Product Change Notice (PCN)

Subject: Change production site of CF/ML process for 8M CMOS image sensor

<Spectral characteristics>

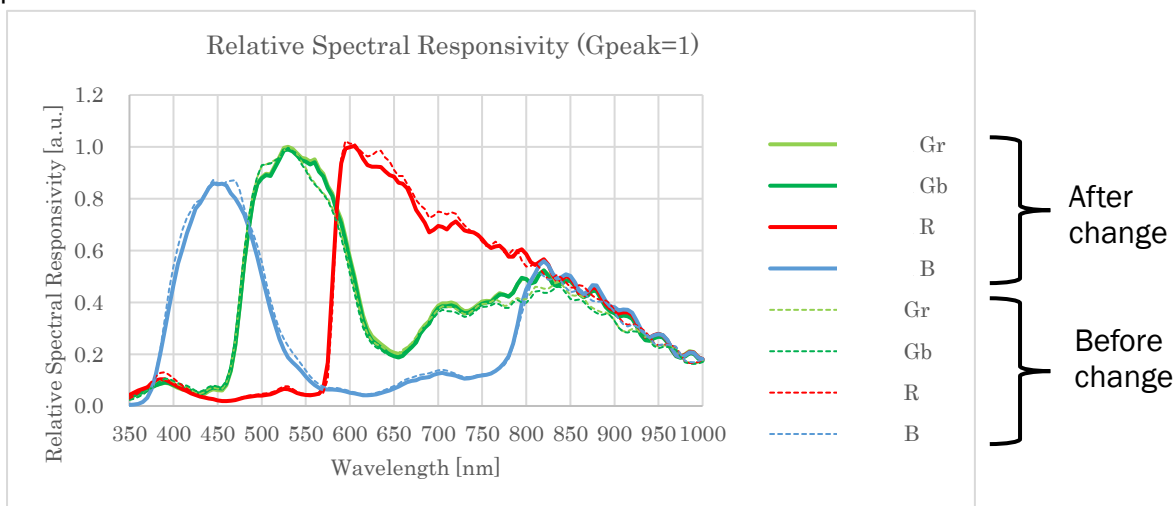
Renesas will change production site of CF/ML (Color Filter/Micro Lens) process from UMC to VisEra.

- Part number will be changed from RAA462113FYL#AC2 to RAA462113FYL#AC6.
- Some specification will be changed.

Item	Symbol	Min	Typ	Max	Unit
Before change	Sensitivity ratio B/G	SENS_B/G	64		88	%
After change	Sensitivity ratio B/G	SENS_B/G	55		79	%
